ACCESS PERMIT APPLICATION

Permit # AC2025-02
Parcel ID: BRO552

Application Date: 3/18/25 Physical Address of Property: 552 Bridge Street
Applicant Name: GARY & JEAN BRESSOR Property Owner Name: GARY & JEAN BRESSOR
Applicant Mailing Address: P.O. Box 1 Owner Mailing Address: P.O. Box 1
RICHMOND, VT 05477 RICHMOND, VT 05477
Phone: 802-363-9300 Phone: 802-363-9300
Email: bressor@wcvr.com Email: bressor@wcvr.com
Description of Project: REMOVE 2nd access. Access for 10 units Is property in floodplain? No

Sketch Plan:

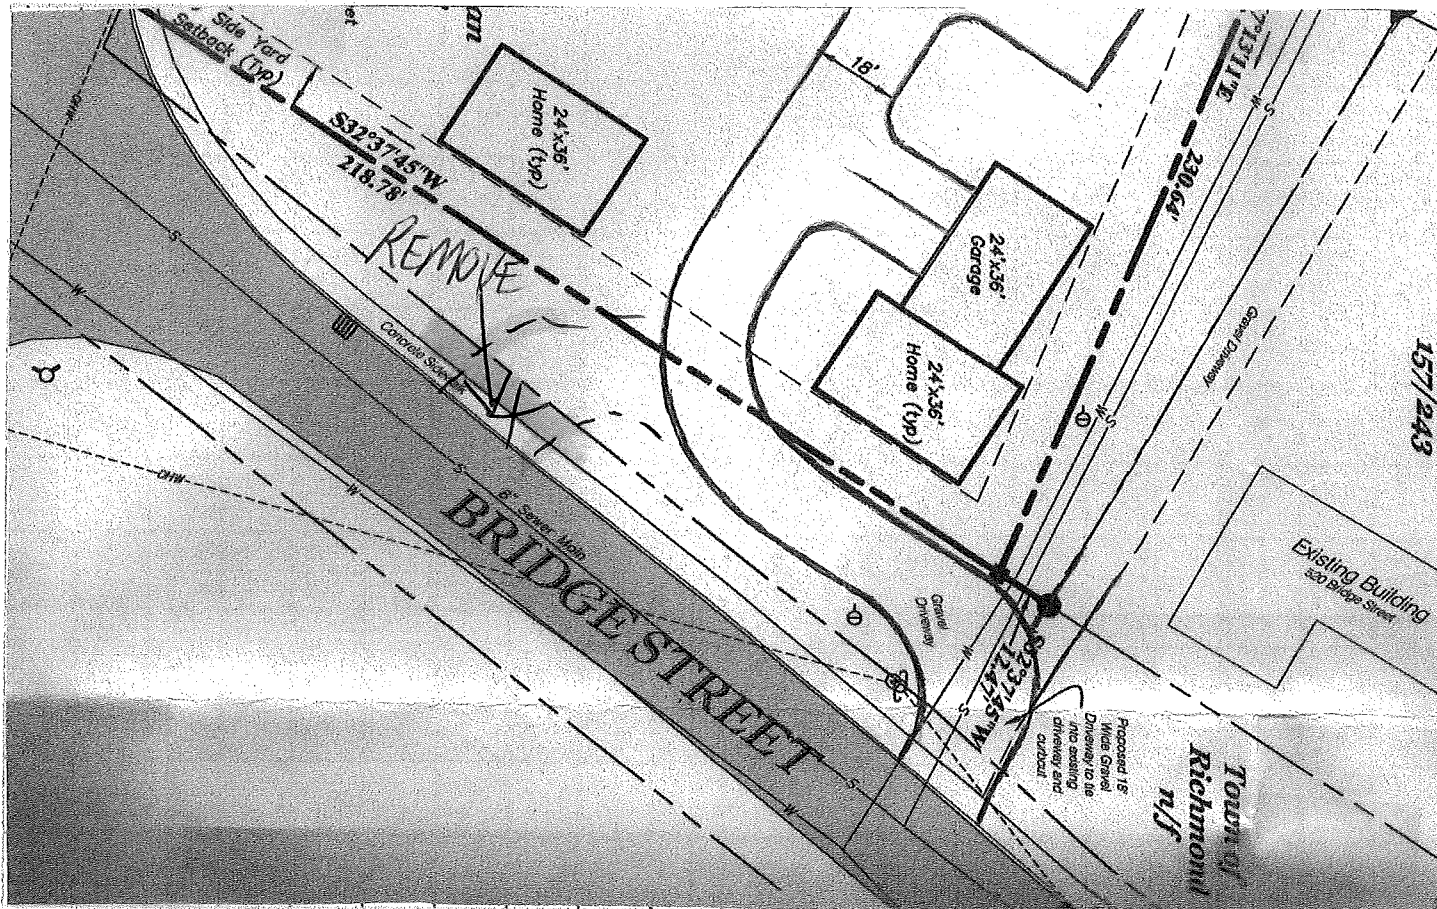
Comments: CURRENT SHARED ACCESS OK. REMOVAL OF Additional comments on reverse

Highway Department Comments: SECOND ACCESS REQUIRES 20' OF SIDEWALK REMOVAL AND REPLACEMENT BY APPLICANT. NEW SECTION OF REPLACED SIDEWALK TO COMPLY WITH RICHMOND PUBLIC IMPROVEMENT STANDARDS.

Is a post construction inspection required? YES / NO Reason for post construction inspection: TO VERIFY PROPER EXCAVATION + INSTALLATION OF SIDEWALK PANELS. INSPECTION BY HIGHWAY FOREMAN.
